UNITED STATES PATENT AND TRADEMARK OFFICE

APPLICATION NO.	FILING DATE	FIRST NAMED INVENTOR	ATTORNEY DOCKET NO.	CONFIRMATION NO.
10/594,657	05/29/2007	Hans Grundei	F0506-1US (E 2452 US)	1641
54380	7590	03/25/2010	EXAMINER	
FLASTER/GREENBERG P.C.			MONTANO, MELISSA ANN	
Four Penn Center				
1600 John F. Kennedy Boulevard			ART UNIT	PAPER NUMBER
2nd Floor				3738
PHILADELPHIA, PA 19103				
NOTIFICATION DATE		DELIVERY MODE		
03/25/2010		ELECTRONIC

Office Action Summary	Application No.	Applicant(s)
	10/594,657	GRUNDEI, HANS
	Examiner	Art Unit
	MELISSA MONTANO	3738

DETAILED ACTION

Fig. 1

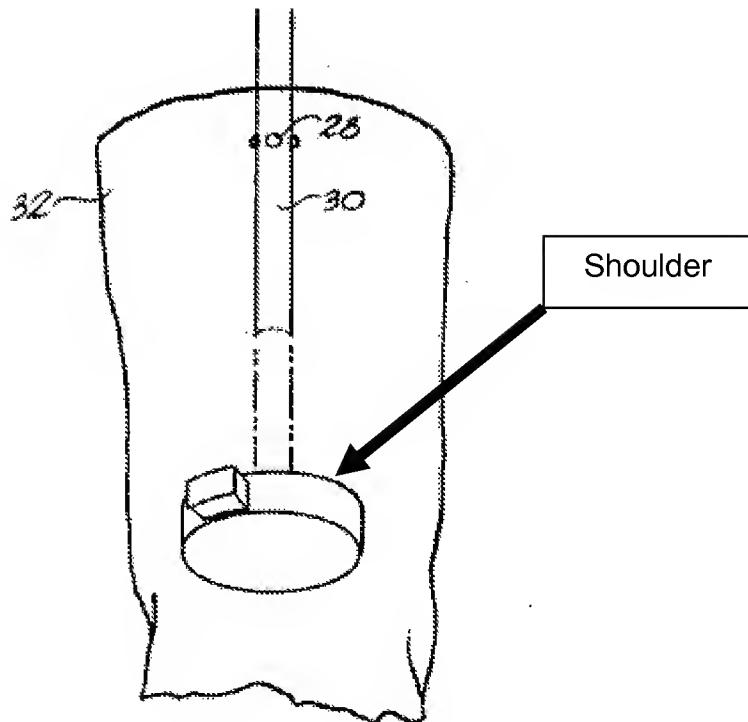
Reswick teaches the mounting according to claim 1. Reswick also teaches a locking pin (adaptation tube; 30) which is shown to be configured to reach inside the sleeve (bush; 20) and be seated in an interference fit (fig. 1). The examiner asserts that the locking pin (adaptation tube; 30) is necessarily capable of being removable, if provided with the proper tools. Further, Reswick depicts the locking pin (adaptation tube; 30) as comprising a length so that it is situated with its distal front edge on a shoulder, which is formed on the extracorporeal device (28 in combination with 30). See figure below.
